CITY OF MIDLAND, TEXAS
AGENDA FOR CITY COUNCIL MEETING
April 12, 2022 - 10:00 AM
300 North Loraine
Midland, Texas
Council Chamber - City Hall

6. 2022-041 – RESOLUTION AWARDING A CONTRACT FOR THE CONSTRUCTION OF THE MIDLAND UTILITIES SERVICE CENTER PROJECT TO MW BUILDERS OF TEXAS, INC., IN THE AMOUNT OF $11,472,440.00; APPROVING $1,977,488.00 FOR CONTINGENCIES; APPROVING $317,000.00 FOR PROJECT RELATED COSTS; AND APPROPRIATING FUNDS FOR SAID PROJECT (DISTRICT 2) (GENERAL SERVICES)

L100

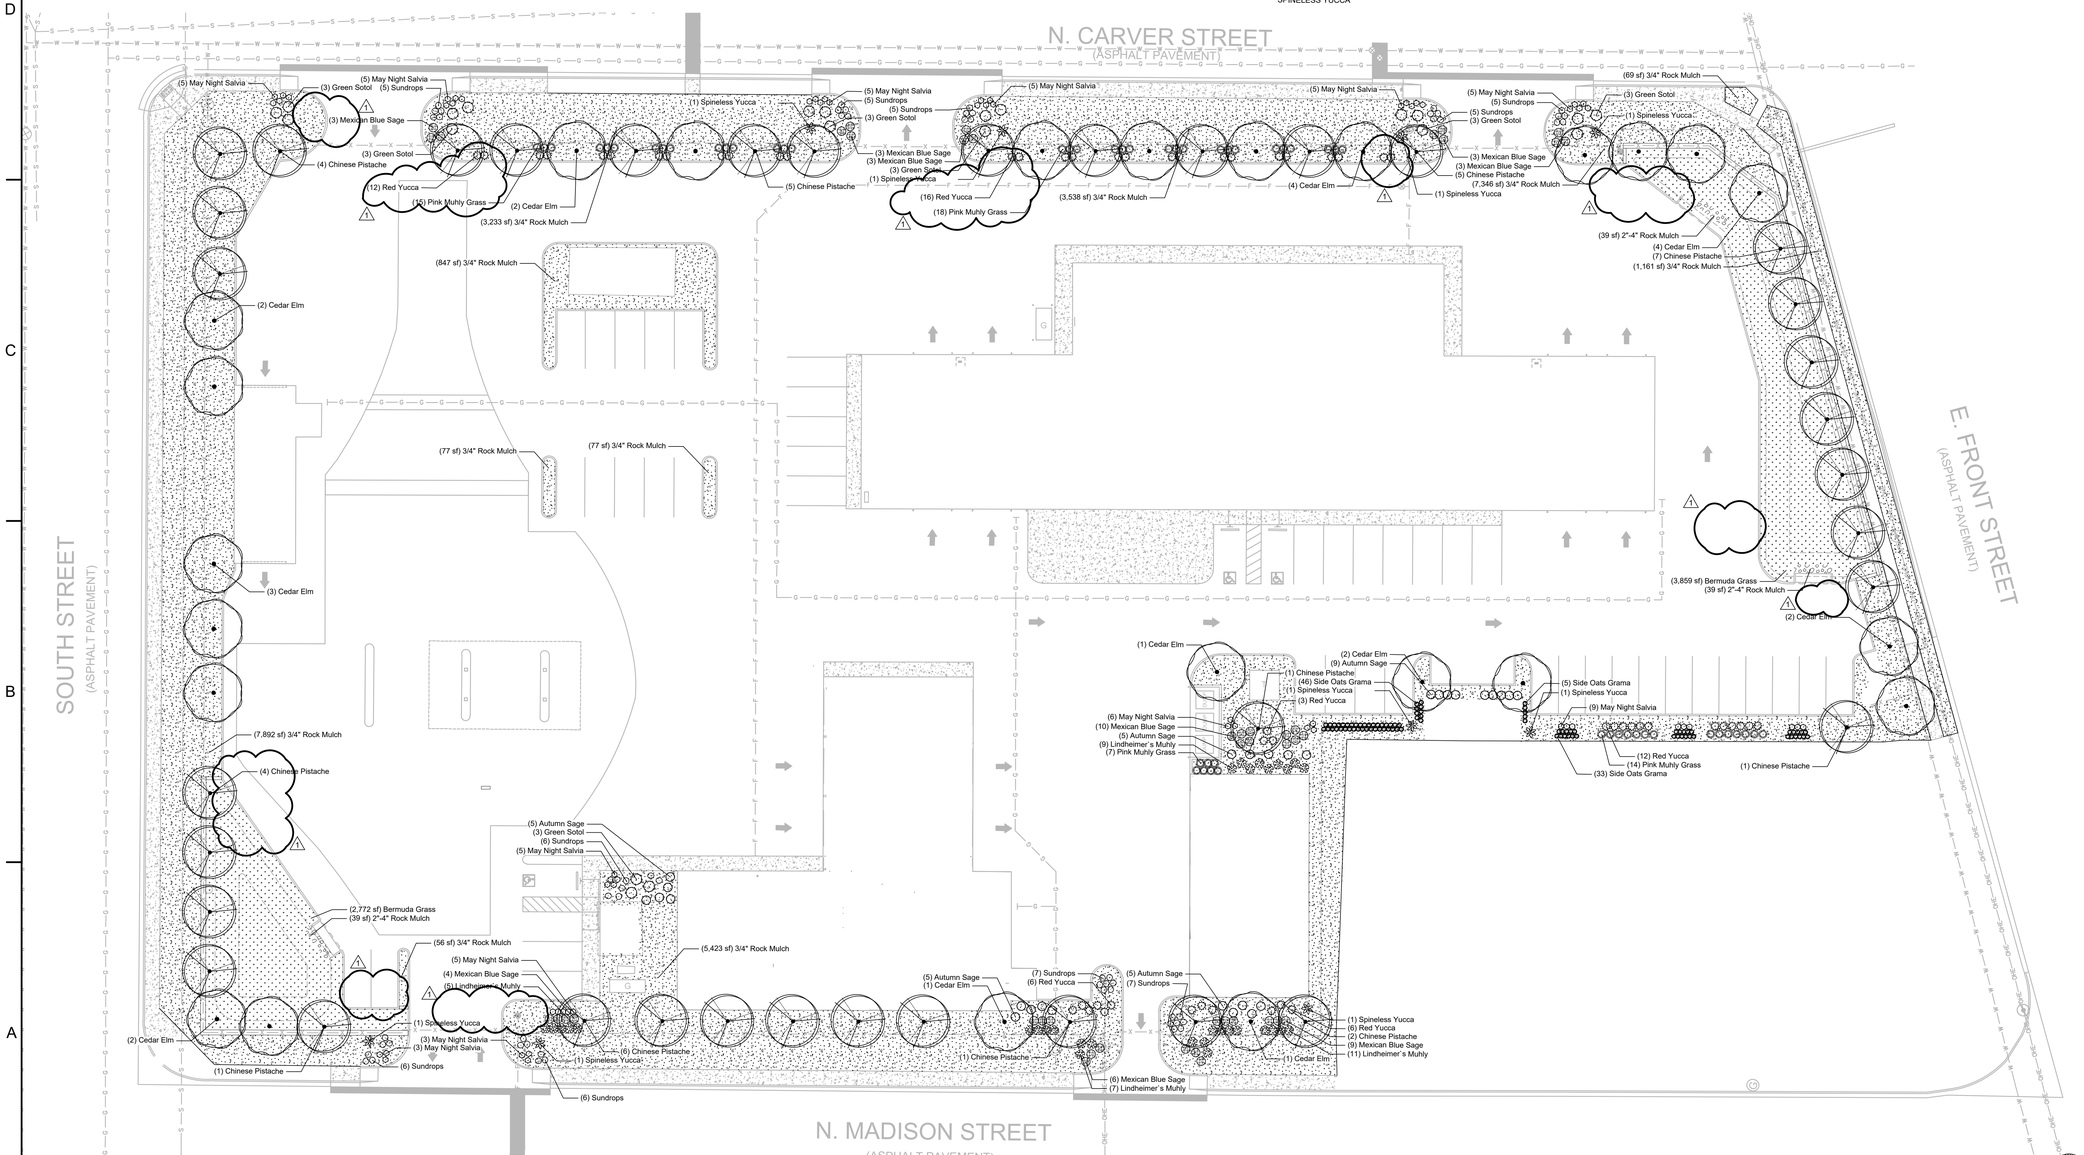
1. SHEET L100 – PLANTING PLAN
   a. REMOVED concrete curb information that was added to the new sheet L101 Landscape Site Plan.
   b. REMOVED plant material in conflict with fencing and/or gates and updated plant quantities.

A1 LANDSCAPE SITE PLAN
1" = 20'

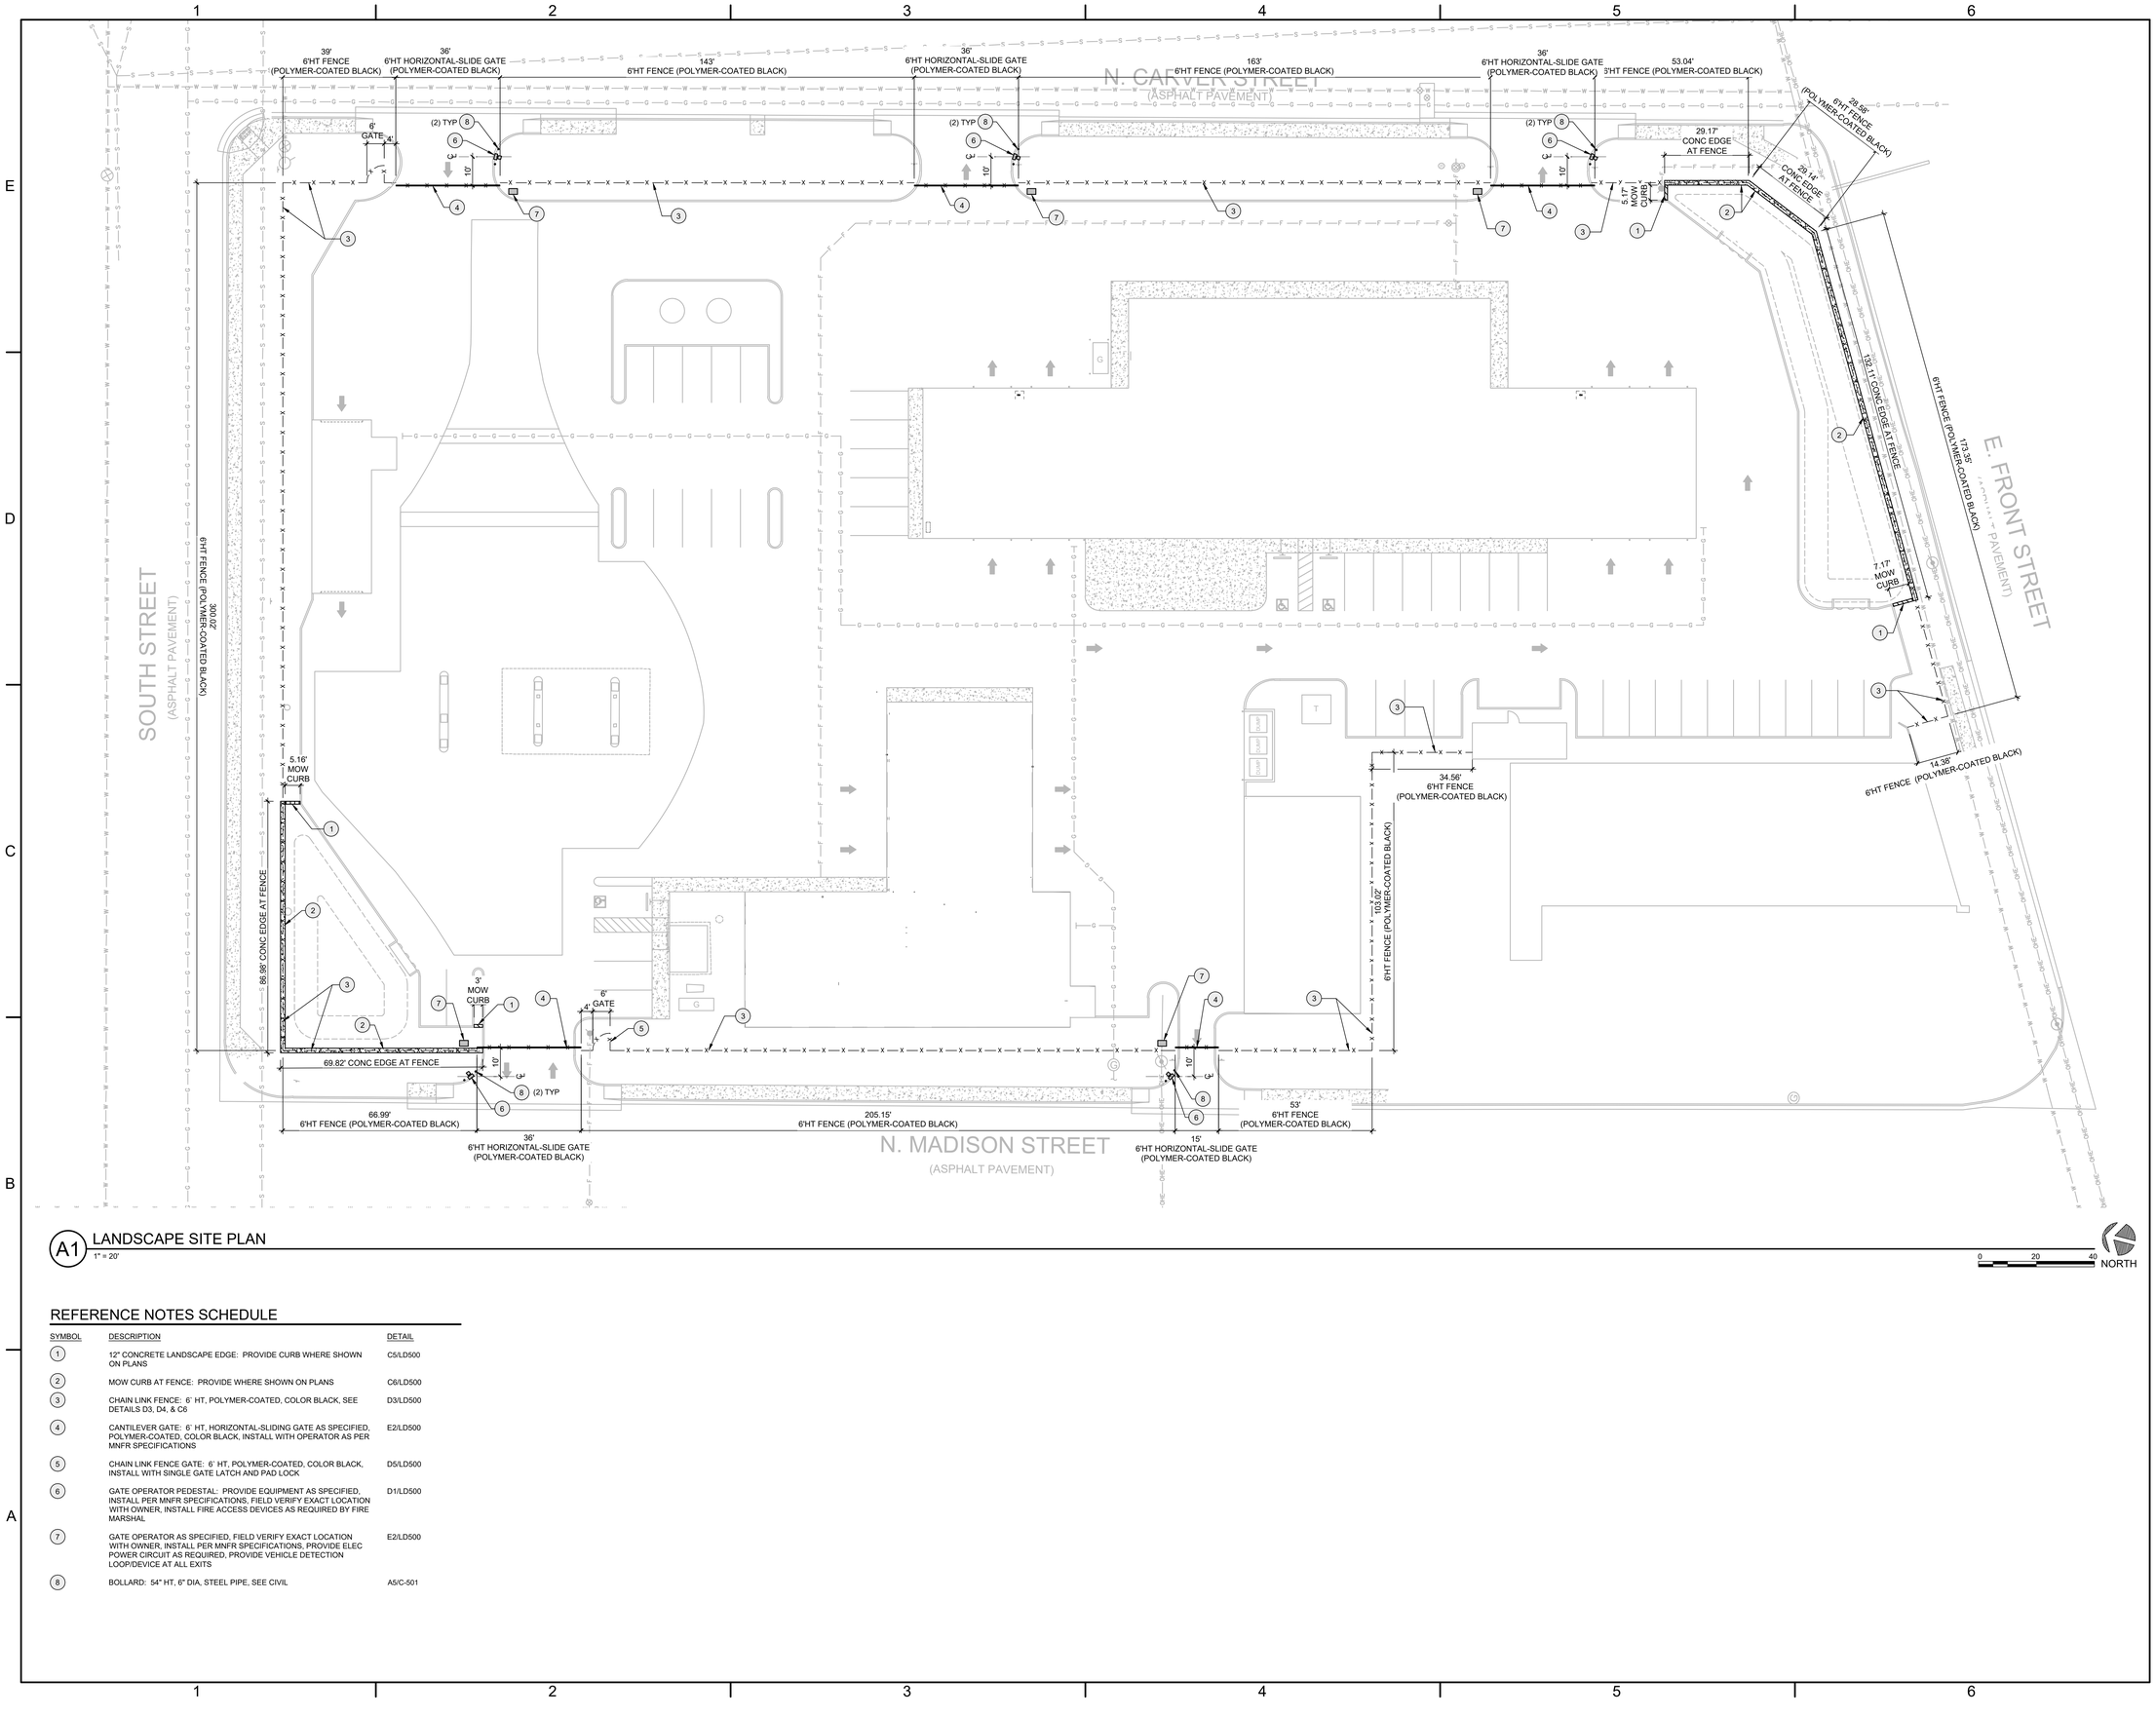
2. SHEET L101 – LANDSCAPE SITE PLAN
   a. ADD in its entirety.
   b. ADDED fence layout information, gate operators, pedestals, and concrete curbs.
3. SHEET A-111 - BUILDINGS A & E FLOOR PLAN, REFLECTED CLG PLAN & ROOF PLAN

A-401

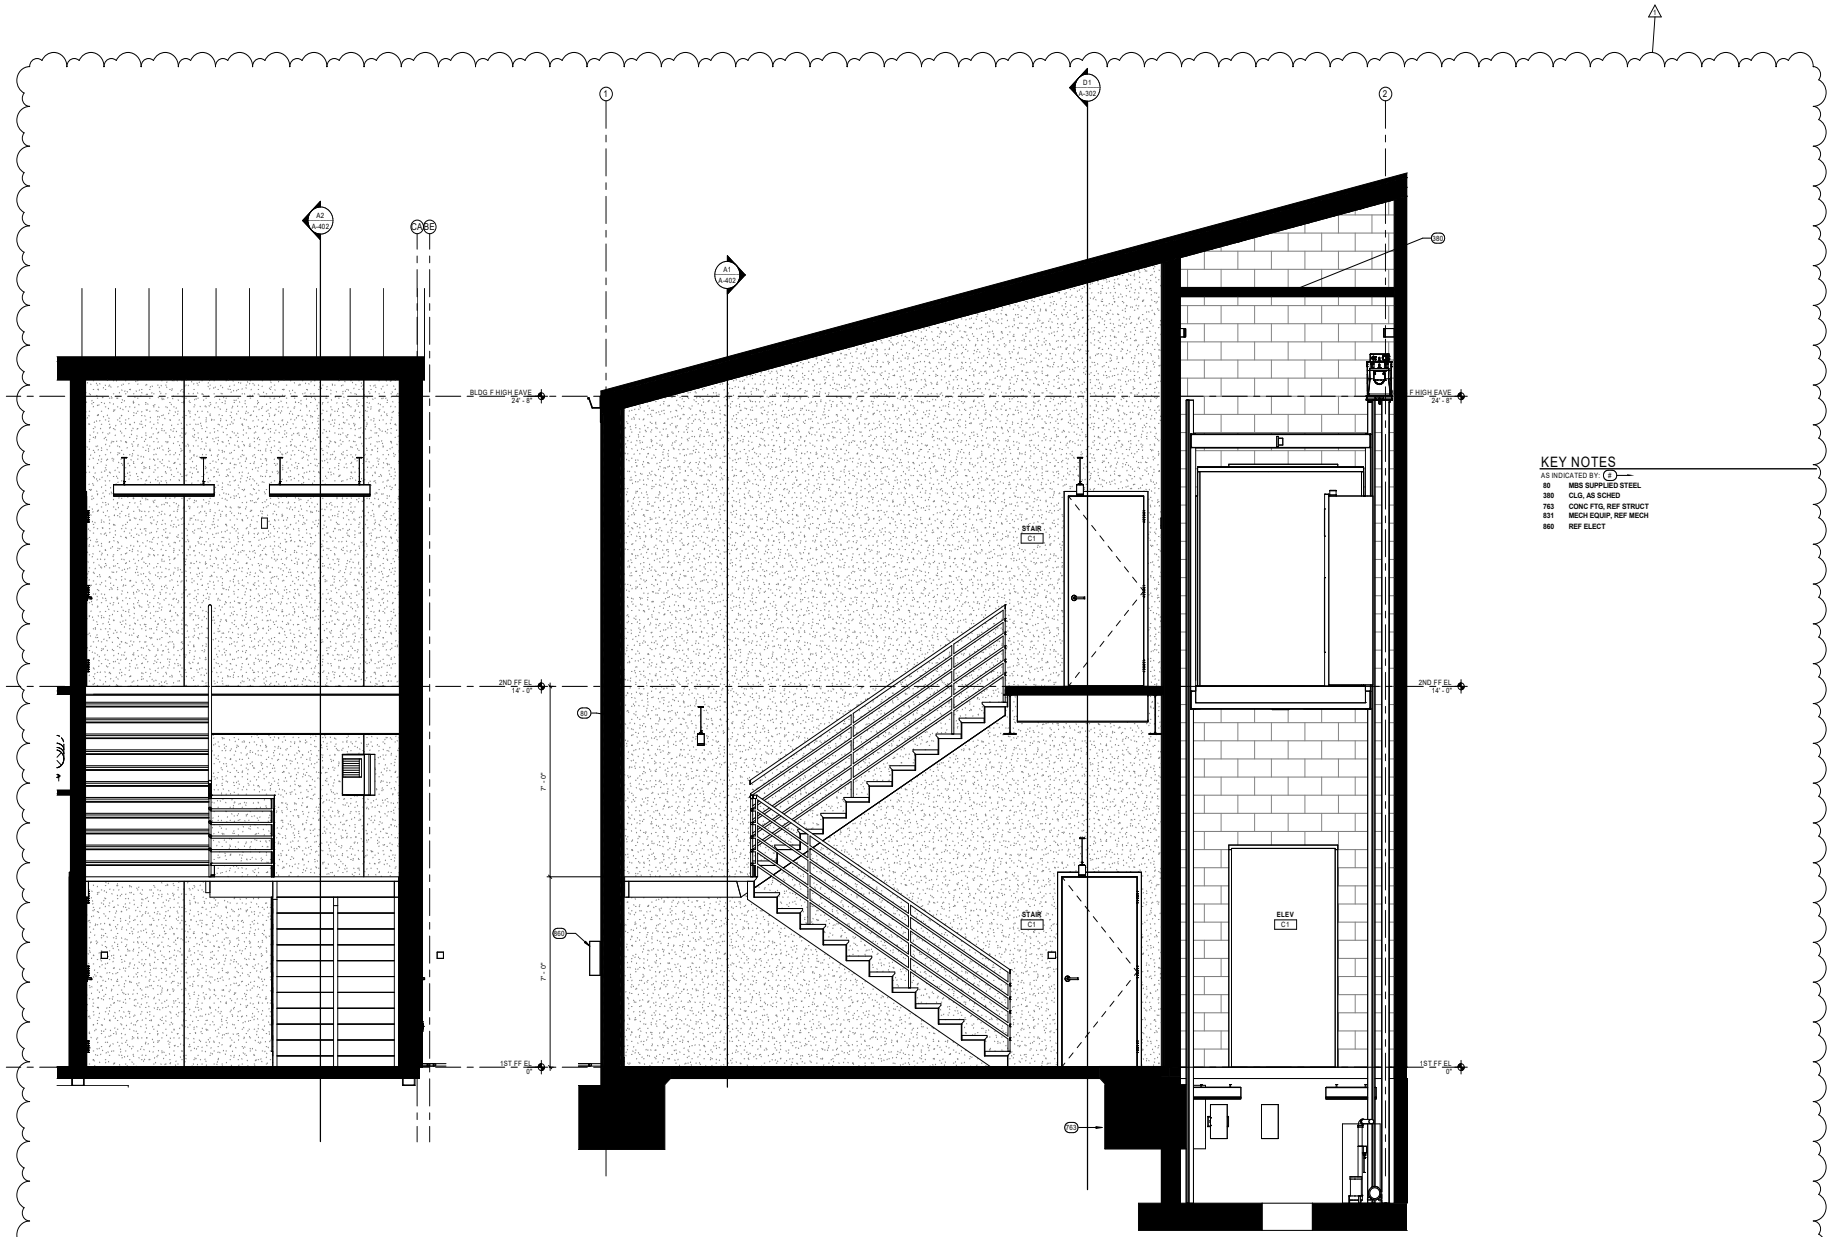
8. SHEET A-316 - WALL SECTIONS BLDG F
   a. Refer to attached sheet A-316. Revisions were made to clarify missing notation.
9. SHEET A-401 - ENLARGED PLANS AREA C STAIRS & ELEVATOR

a. Refer to attached sheet A-316. Revisions were made to clarify missing notation.
10. SHEET A-402 - STAIR SECTION BUILDING AREA C
    a. Refer to attached sheet A-402. Revisions were made to clarify missing notation.
